Planning Commission Regular Meeting

Item Name: Public Hearing, 210 George Street, Residential Review Permit and Variance (PC No. 25-07) - continued from June 23, 2025, meeting

Excelsior Good Neighbor Guidelines PLAN Review

210 GEORGE STREET

PROPOSED SURVEY

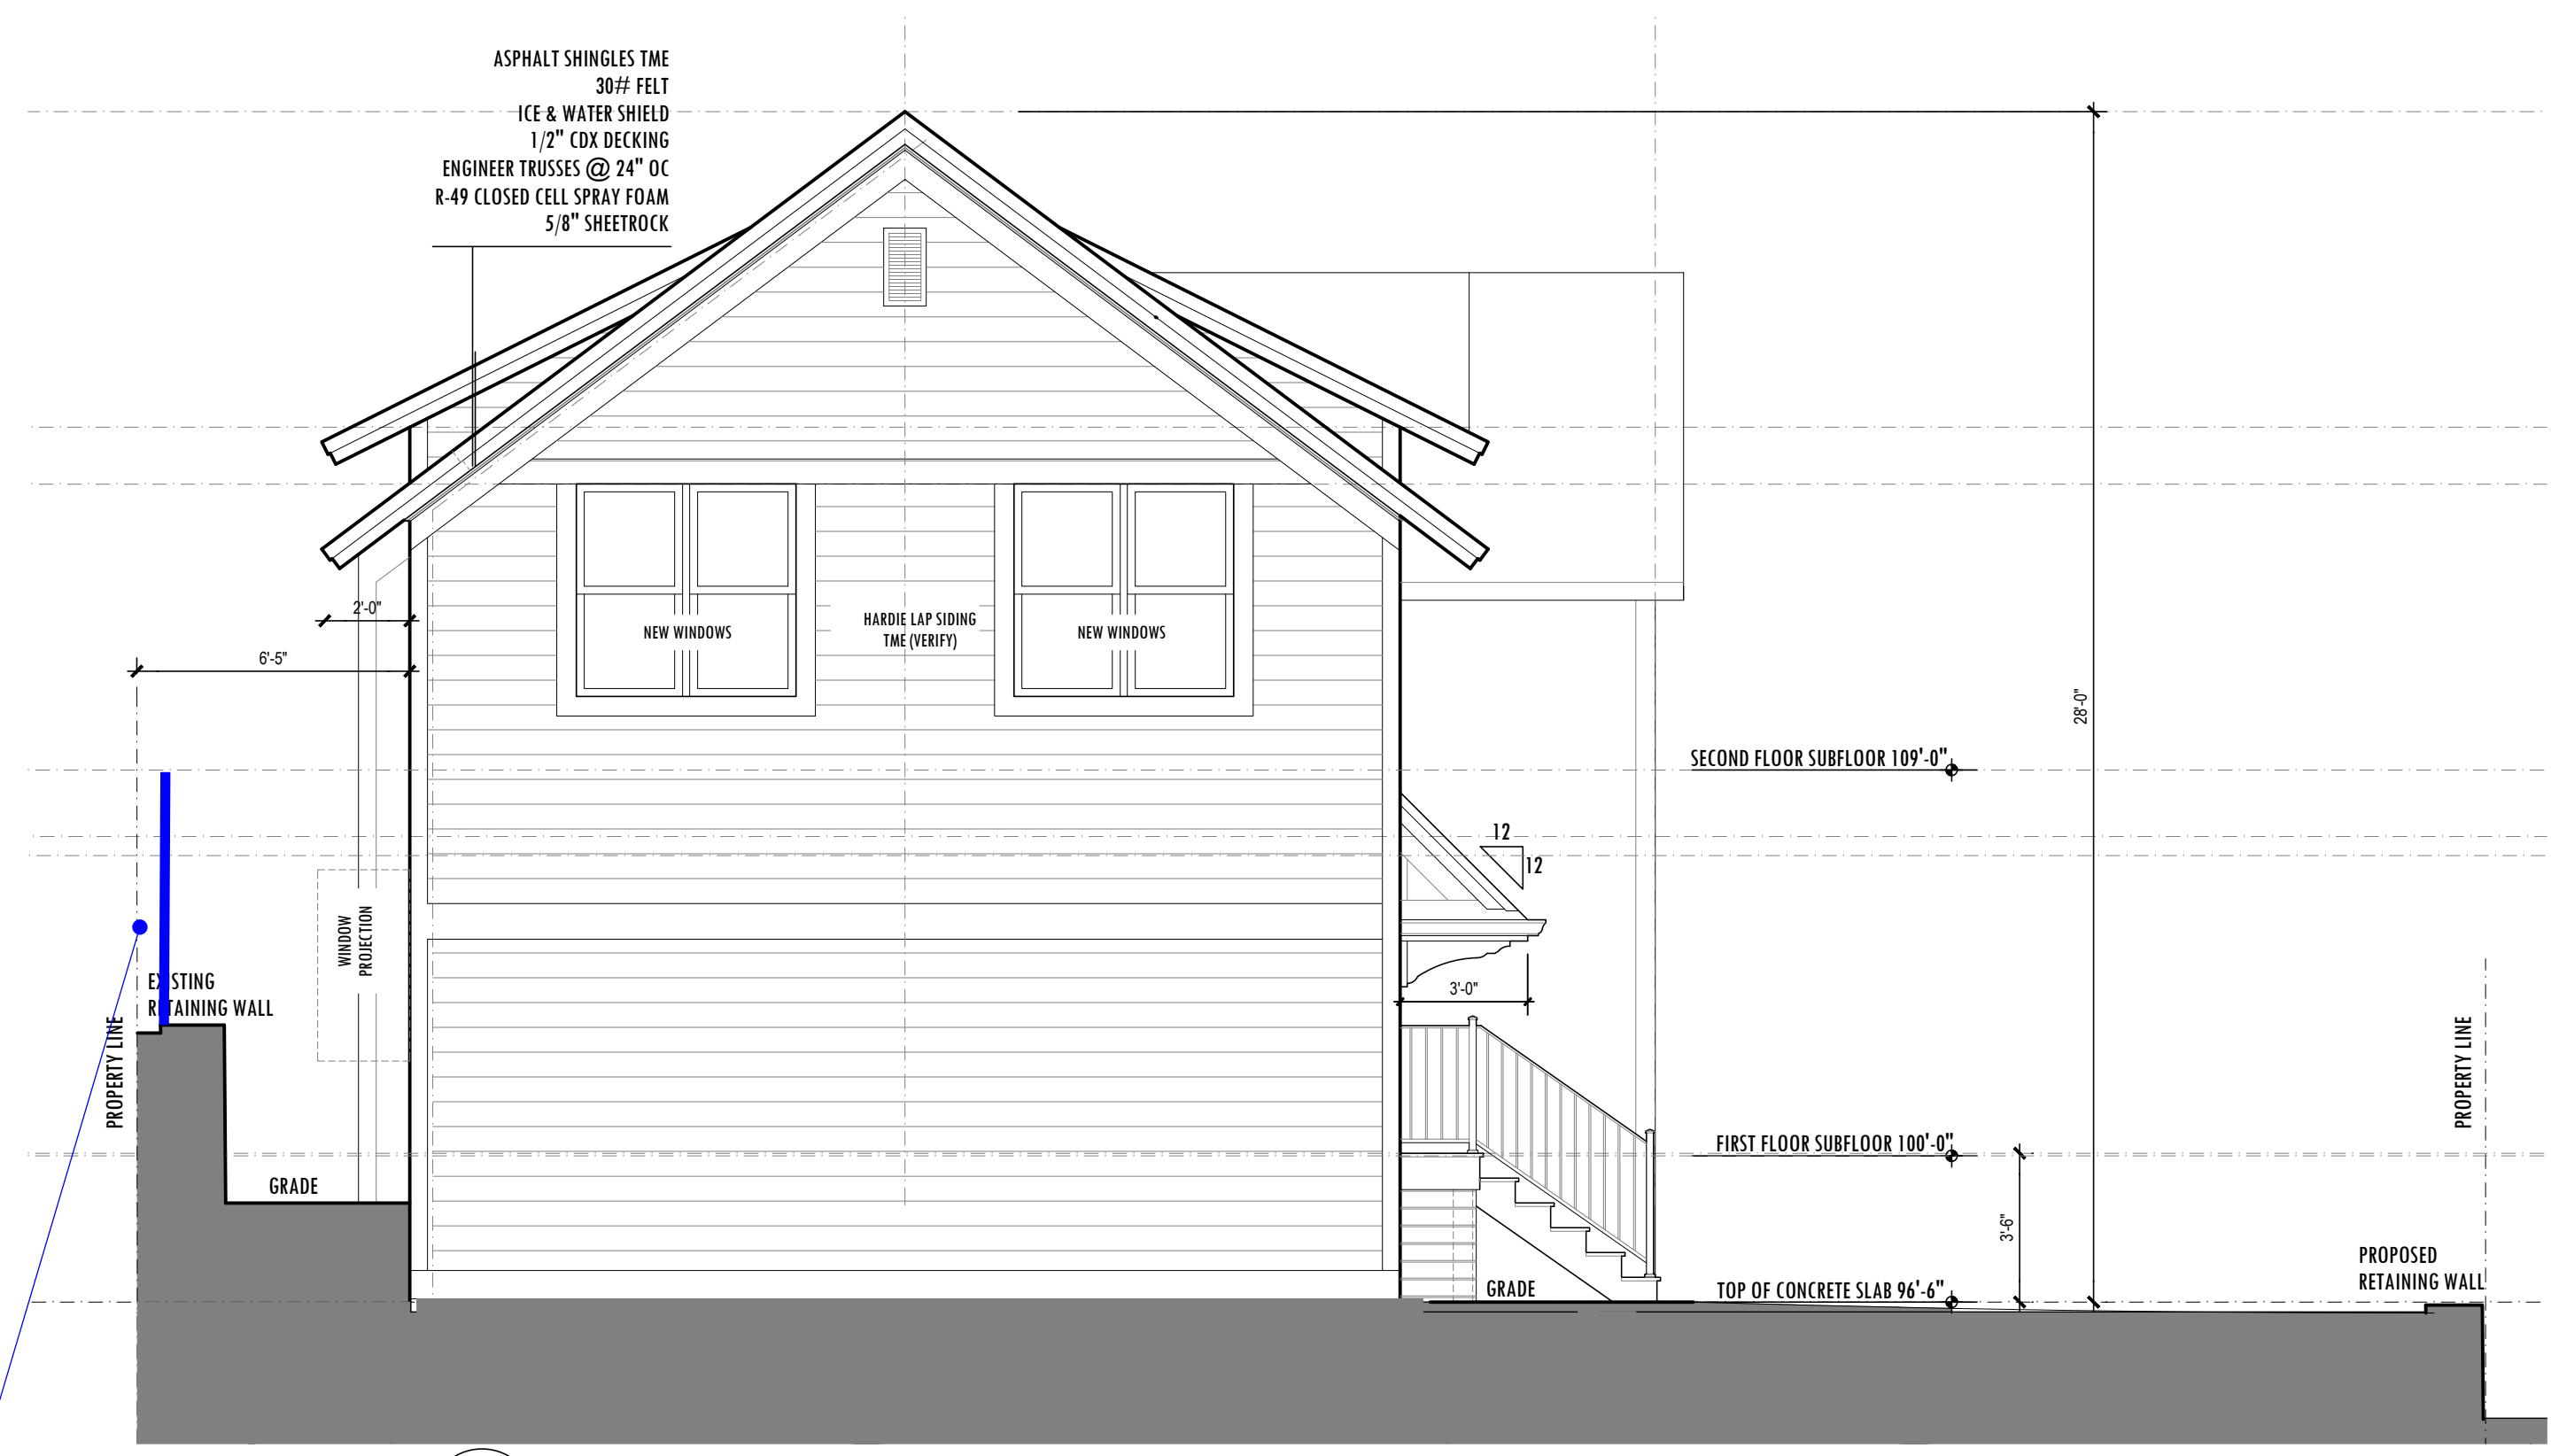
1. The applicant confirmed that half of the “vacated alley” illustrated on the survey at the rear of the parcel is part of the subject parcel, and they submitted an updated survey. This adds a 343 sf area to this parcel, an area approximately 6.5' x 55'. The parcel size has increased from 6,431 sf to 6,774 sf. As a result, there is a larger rear yard on this parcel and the applicant no longer requires a rear yard variance.

2. With the increase in parcel size, the proposed building coverage is now 26.5% instead of 28.8%. A variance is still required, however, the request is smaller than what was presented on June 23rd.

4. With the increase in lot size, the proposed lot coverage is now 40.8% instead of 42.9%. The application continues to propose a reduction in lot coverage.

information prior to building permit. The rain garden needs to be sized appropriately so that overflow does not impact the direct neighbor's yard, and water should be flowing to the rear of the parcel to the vacated alley area. Grading will be finalized with the requirement that the addition does not increase stormwater runoff onto neighbor's property.

1
PROPOSED REAR ELEVATION
 A3.1 SCALE 1/4" = 1'-0"

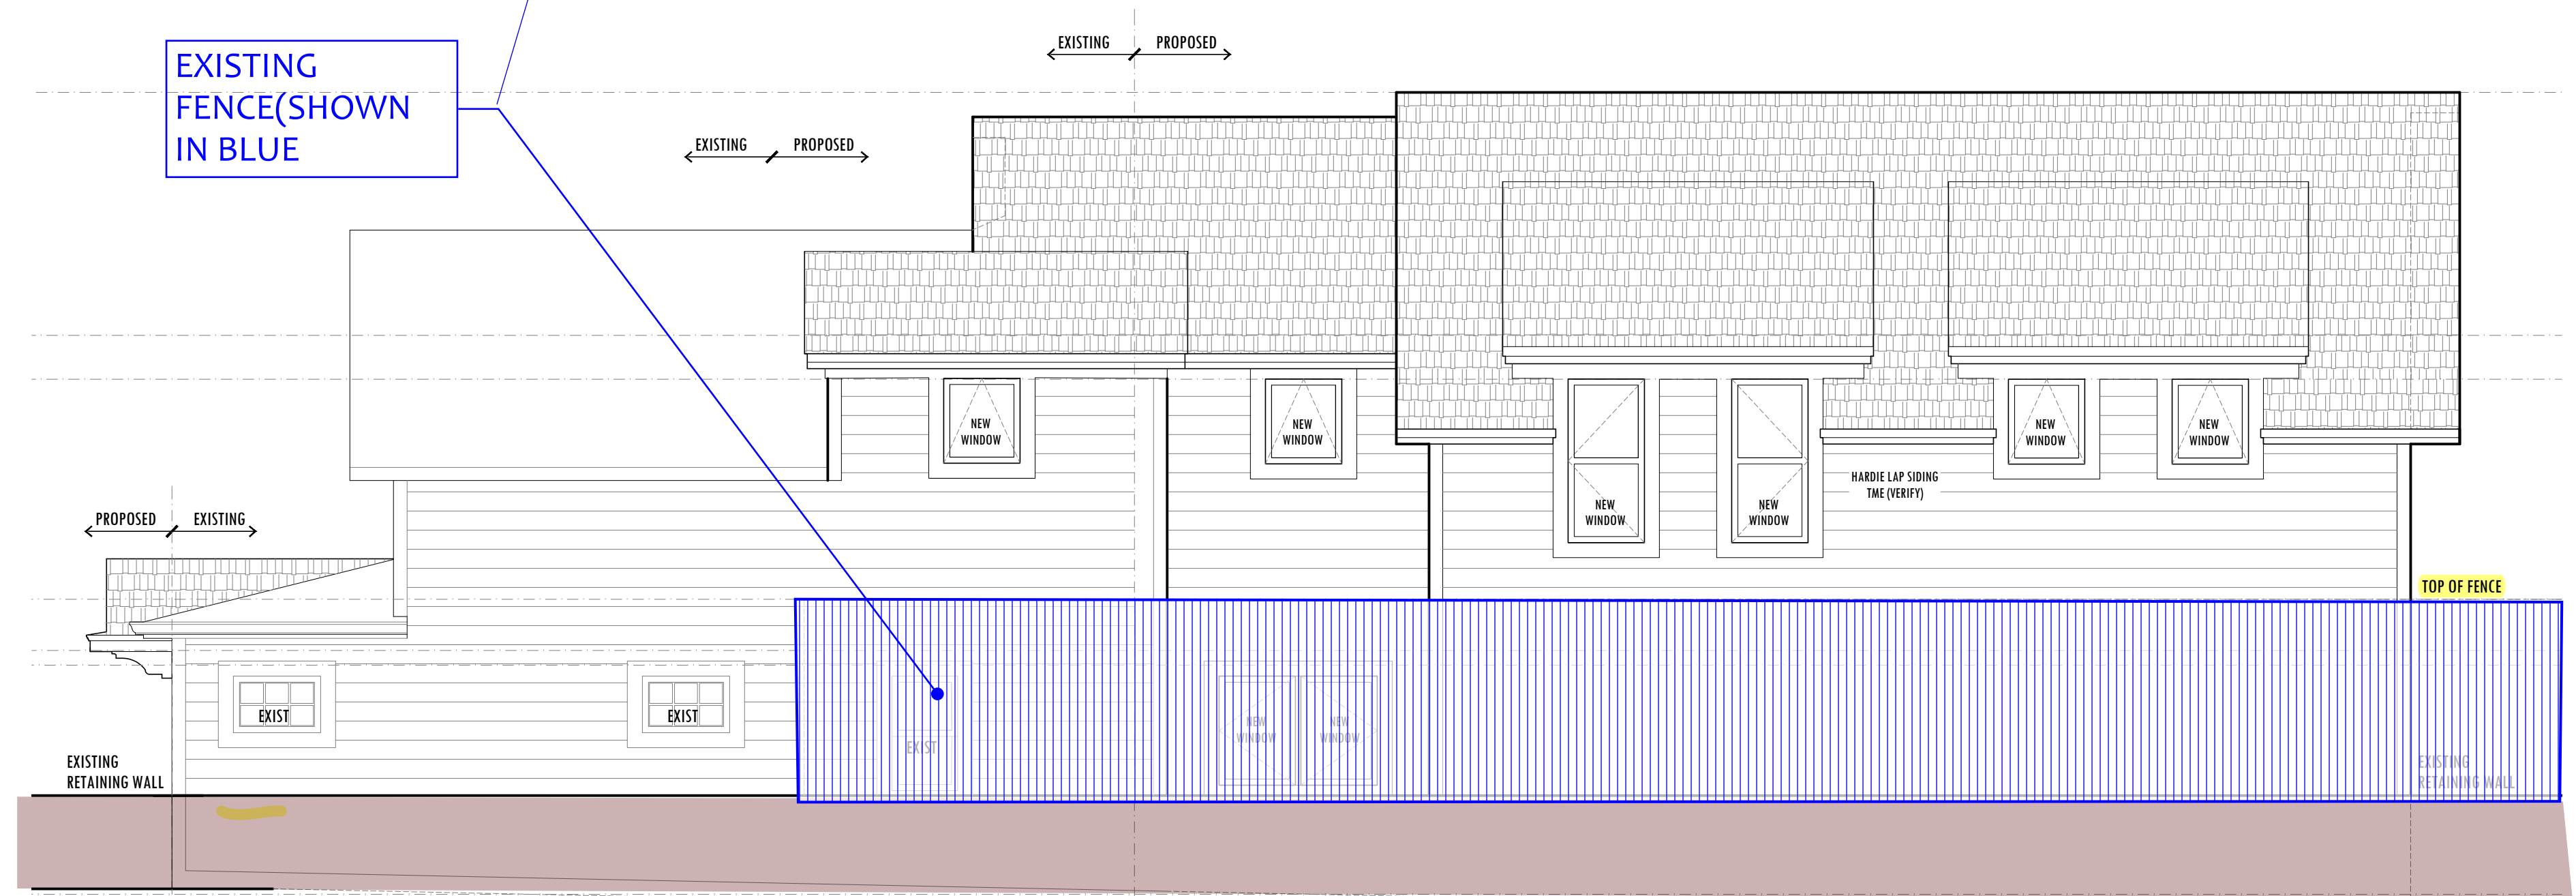
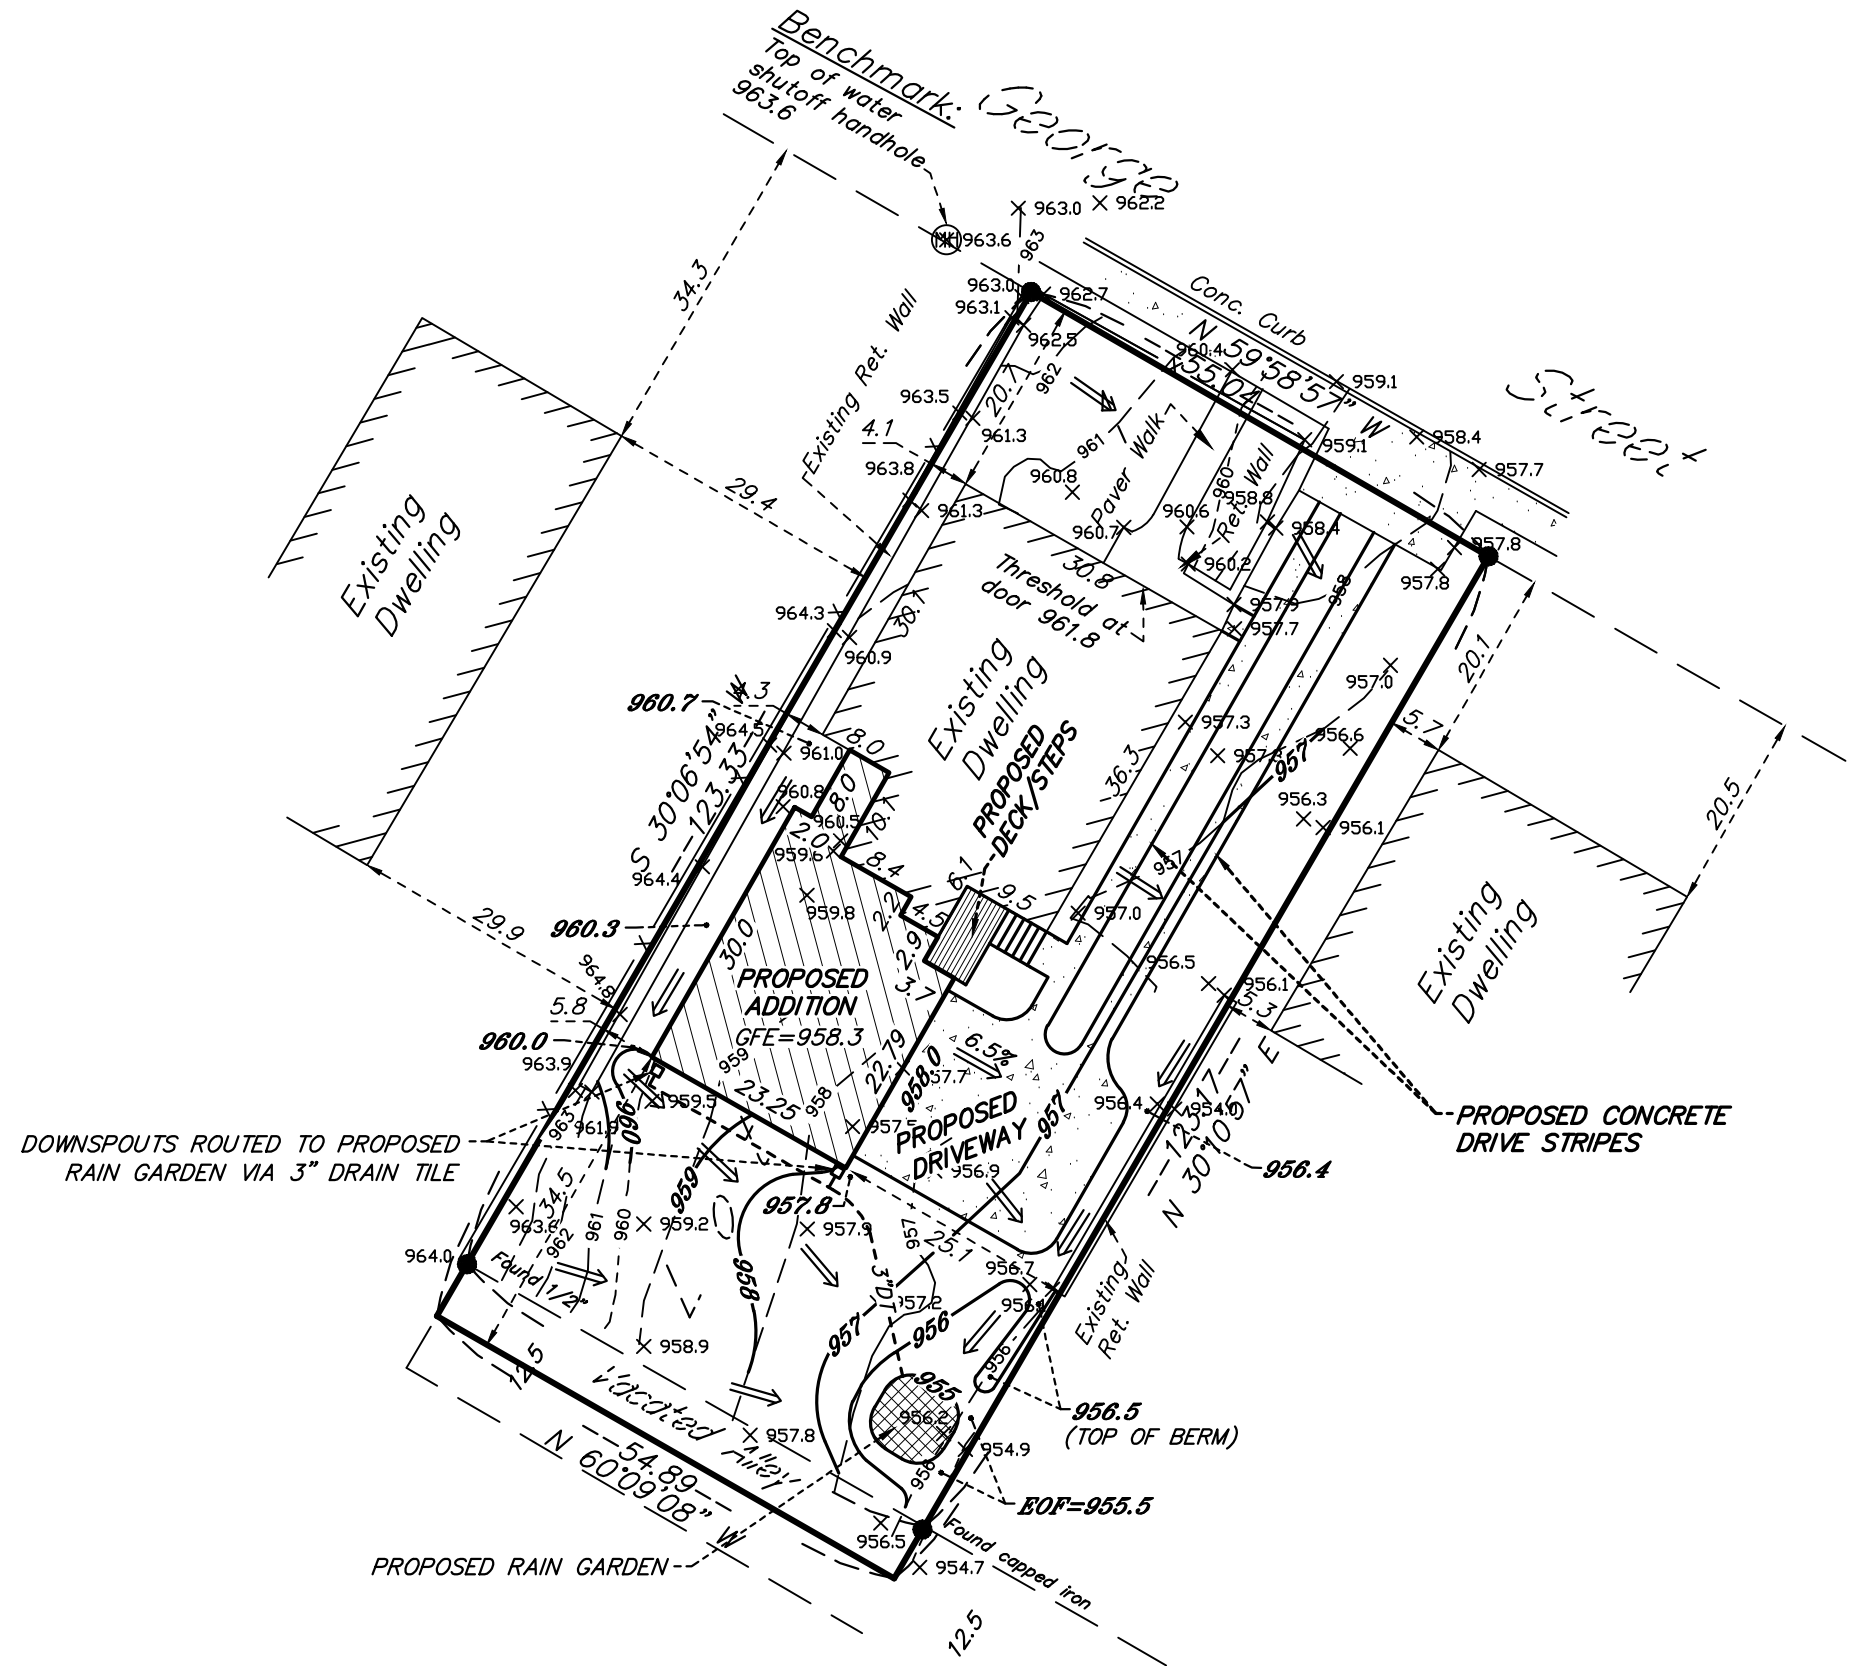
3. The applicant reduced the height of the addition. The original plans showed the roof peak of the addition 3'9.5" higher than the roofline on the existing house. The revised plans show the addition 1'8" taller.

The façade of the original home will be preserved. The addition does not significantly impact the streetview of the home. The addition is large and its position behind the home will be somewhat noticeable from public view because the peak of the addition's roof (1'8" above existing roofline) will be visible from the street. This will change the original roof line but does not necessarily detract from the character-defining elements of the home. The new addition also has dormers that work to blend the new addition to existing home's style and character. During the pre-application period, the applicant worked with staff and reduced the height of the addition, reduced the size of the garage, and added dormers, thereby reducing the size of the side setback, rear setback, and building coverage variances required. Garage height was again reduced after the June 23rd Planning Commission initial review.
